PLANNING DEPARTMENT – Development Review Services

July 17, 2014

RE: **El Manzanal Subdivision** - 704 Griegos Road, NW
Conceptual Grading & Drainage Plan
Engineer's Stamp Date (none) (File: F14D069)

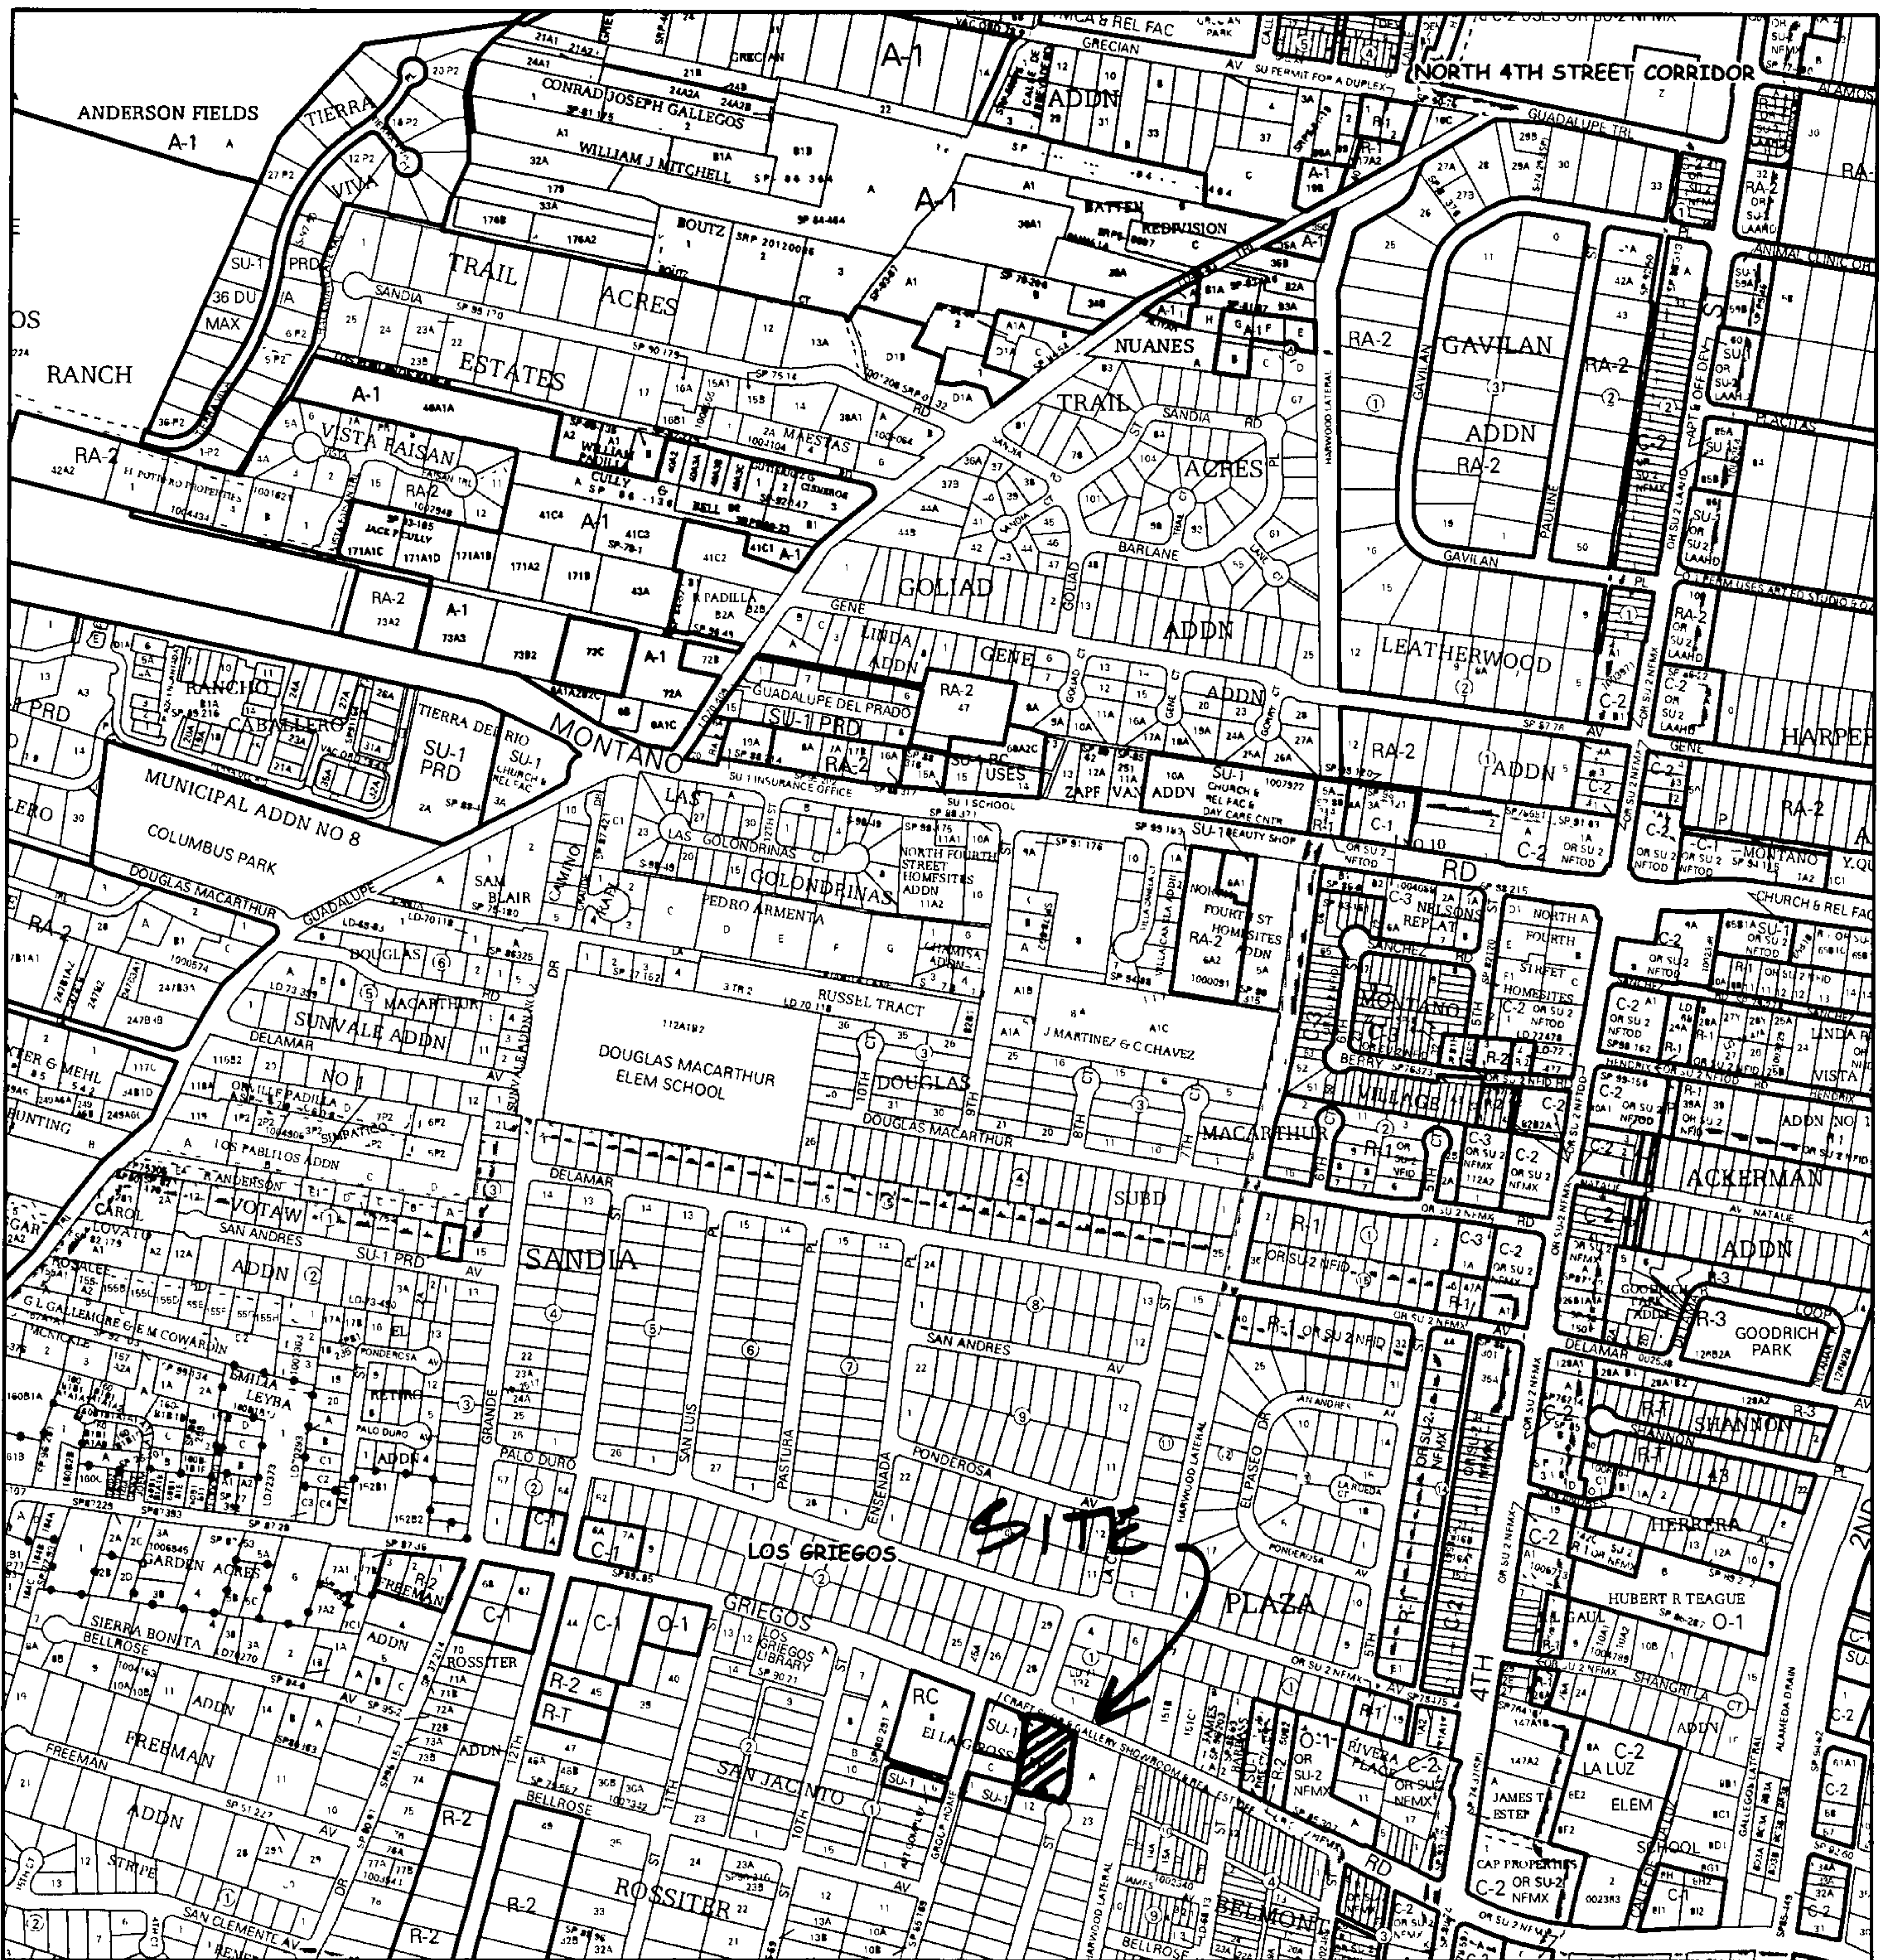
1. Show existing spot elevations/ contours on site and adjacent to property
2. State how the first flush is to be managed.
